ASPECT INDUSTRIAL ESTATE

Response to Submissions
SSD-10448

Figure 5 MRP DCP – Road Network Map

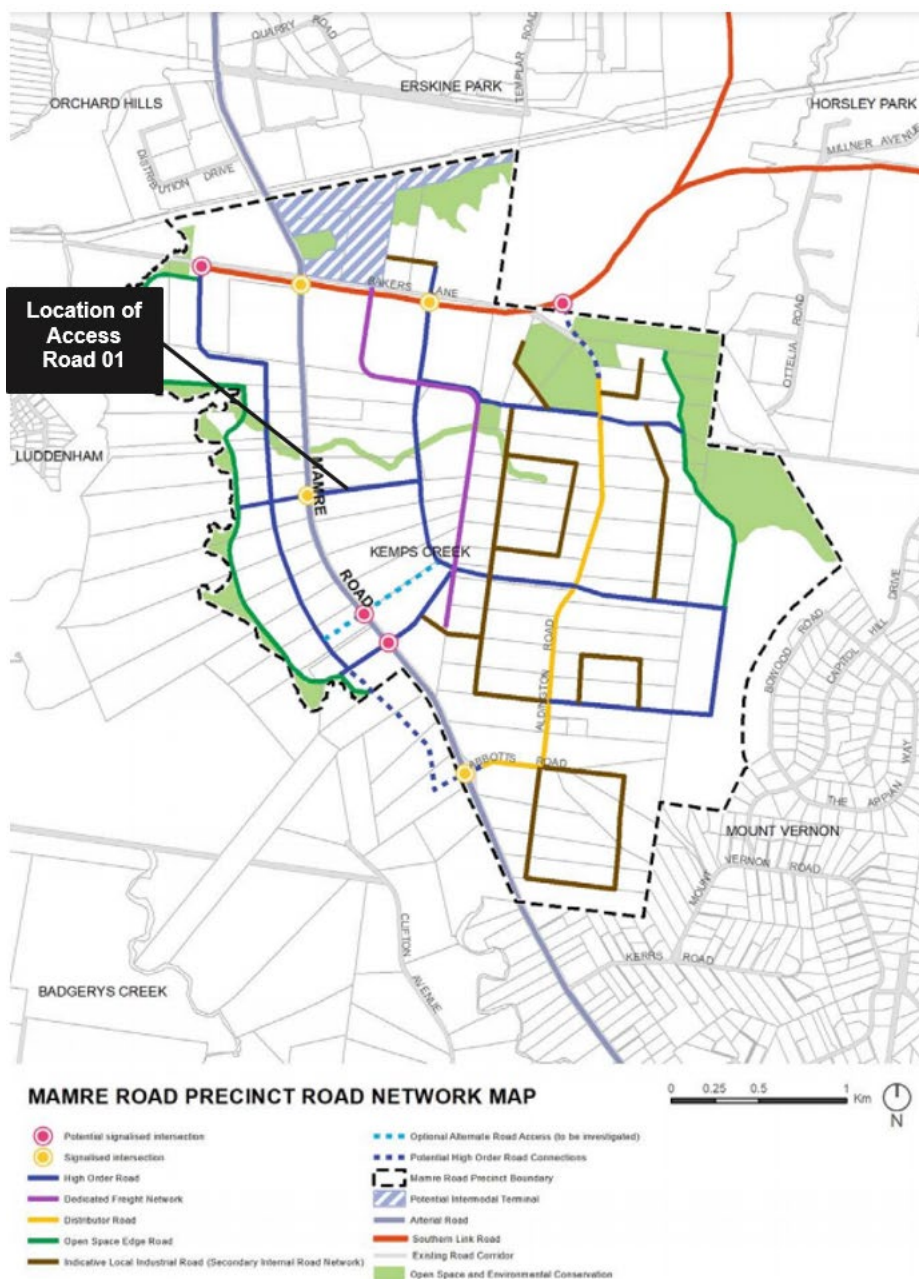
Access Road 1 is defined as a High Order Road under the MRP DCP (refer to **Figure 5**). Due to this classification, it is not subject to this restriction. As a result, the current access arrangement to and from warehouses on Access Road 1 is consistent with the draft MRP DCP.

The draft MRP DCP requires Access Road 1 and Access Road 3 (as part of a north-south collector road) provide access to the adjoining sites to the north, east and south. The development must consider the access requirements (including the timing of providing access) for these adjoining sites to enable the orderly development of Mamre Road Precinct.

Figure 6 Subdivision Plan

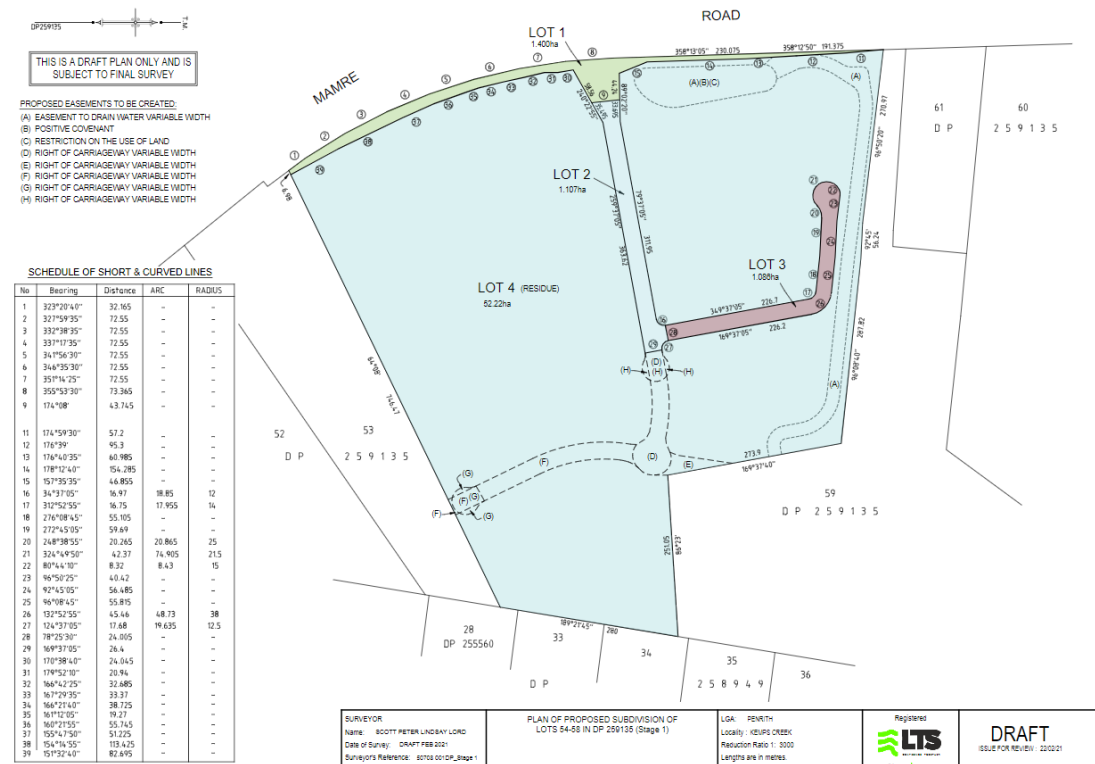
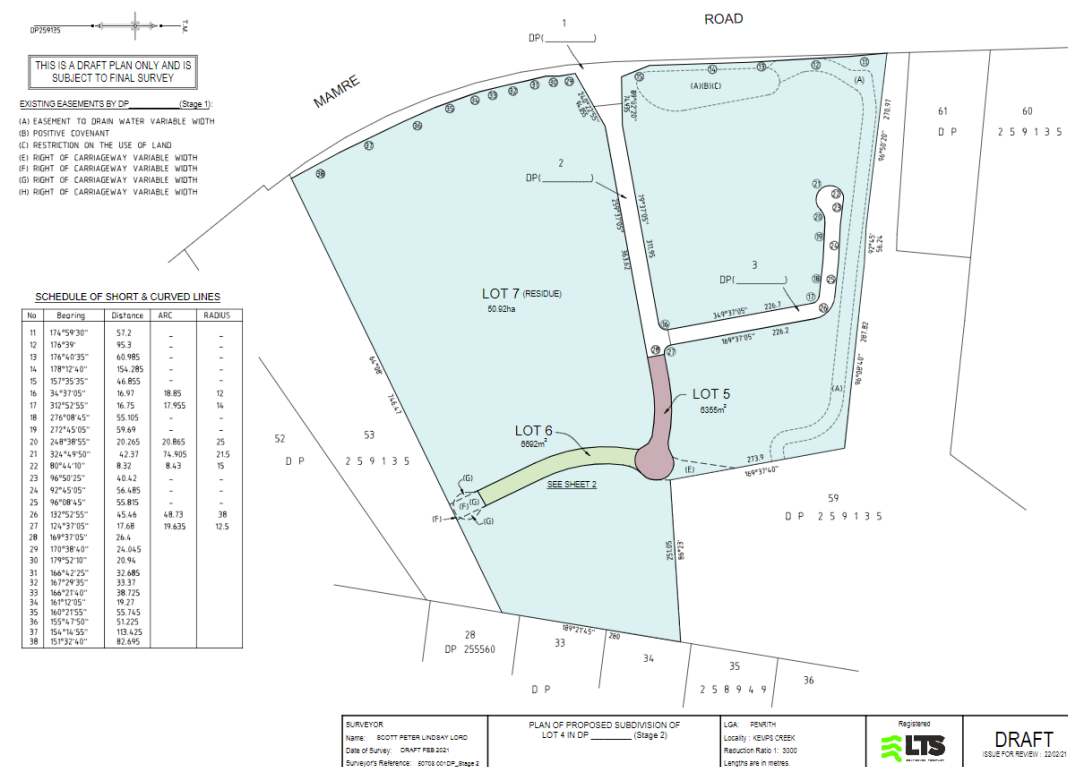
Following a review of the submissions received during exhibition, it is noted comments were raised in relation to the staging and timing of this access. The Stage 1 Plans have been updated (refer to **Figure 2** above) to include the following:

- extend Access Road 1 to AIE's eastern boundary and construct roundabout. A right of way to be provided benefiting GPT to ensure access is available to their site via AIE Estate Road 1 prior to construction of Access Road 3 north;
- provide temporary access to the north;
- deliver Access Road 3 south which facilitates future connection to the south. Provide right of way benefiting Altis to ensure access is available to their site via AIE Access Road 1 and Access Road 3.

A Right of Way is to be provided across Access Road 1 and 3 and across the temporary access points onto adjacent lots prior to completion of the Estate Road network to ensure access is available to adjoining lots during construction phase. This is documented in the proposed subdivision plan (refer to **Figure 6** below).

Figure 7 Typical Riparian Cross Section

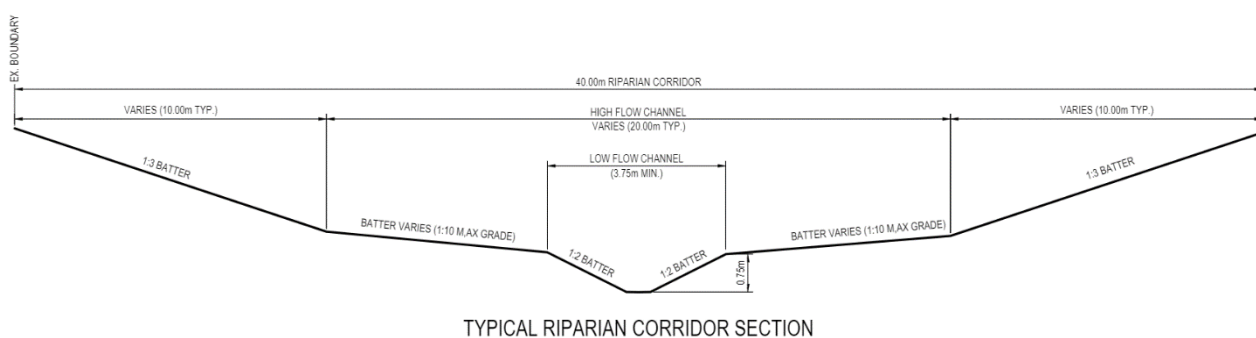
The DPIE notes the width of the proposed creek channel is inconsistent between documents. The Riparian Assessment Report states the channel would be 4.75m wide, whereas Sections 1 and 2 in the Civil Drawing (No: 18-596-C1010) show the low-flow channel would be 5.6m and 5.7m wide respectively. Furthermore, the typical riparian corridor section in Civil Drawing (No: 18-596-C1006) shows a 3.75m wide low-flow channel within a 20m wide high flow channel. Please clarify the width of the channel.

The low flow channel width varies due to the existing topography at the boundary and the proposed development. The riparian corridor section on Civil Drawing 18-596-C1006 has been updated (refer to **Appendix C**). The typical low flow channel width is 3.75m. However, the channel width varies between 3.75m and 5.7m.

The updated Civil Plans for the riparian corridor have been provided to Ecological Australia to update the Riparian Assessment Report. This report and associated Vegetation Management Plan (VMP) have been updated to reflect the levels and alignment of the proposed creek channel. These are included at **Appendix I** and **Appendix J**.
